The Houston Council of Engineering Companies' Joint Storm Water Quality Subcommittee has spent the past year reviewing the Best Management Practices for Stormwater Runoff. With the encouragement of staff members of the City of Houston, Harris County, and Harris County Flood Control District, we undertook this challenge because seven years has passed since the original issue of the criteria and we thought it would be a useful undertaking to apply some of our lessons learned to the BMPs. With the approval of the HCEC Drainage Committee, Design Standards/Plan Review Committee and the HCEC Board of Directors, I respectfully present to you our recommendations for updating the "Minimum Design Criteria For Implementation of Certain Best Management Practices for Storm Water Runoff Options", published in 2001.

Recommendations from the Storm Water Quality Infrastructure Working Group of the Joint Storm Water Quality Subcommittee of HCEC May 30, 2008

It is the belief of the working group, that these recommended changes would work best if they amended the document "Minimum Design Criteria for Implementation of Certain Best Management Practices for Storm Water Runoff Options" published by Cit

ORIFICES

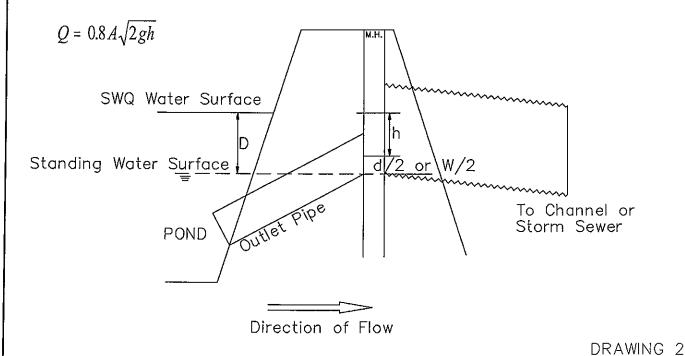
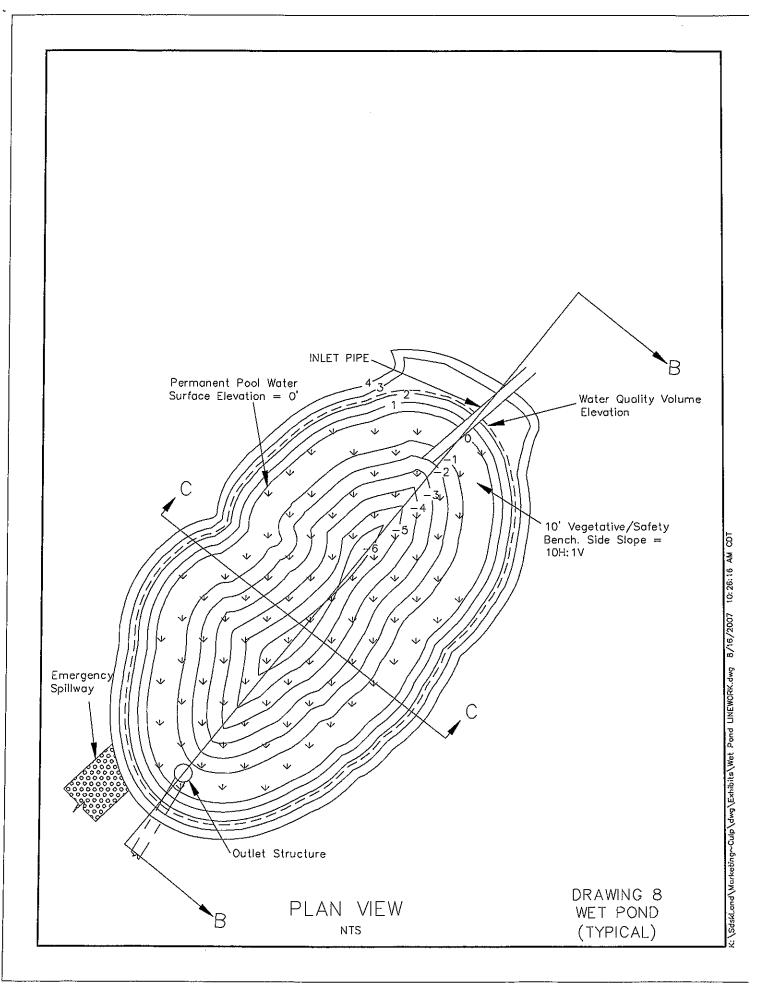
3. Orifices

Q=0.6 A (2gH)^{1/2}. (HCFCD Manual, section 6.7.6) H measured from center of orifice to water surface. The minimum orifice diameter should be 2 inches.

4. Inverted Pipes

Q=0.8 A (2gH)^{1/2}. (HCFCD Manual, section 6.7.6) H measured from center of inverted pipe at outlet side to water surface.

DRAWING 10
WET POND SAFETY/
VEGETATIVE CROSS SECTIONS

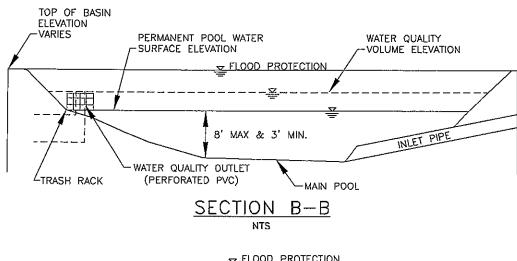
TO MINIMIZE VEGETATIVE MAINTENANCE, WET SHELVES SHOULD BE CONCRETE EXCEPT WITHIN 30' OF OUTLET STRUCTURE OF POND
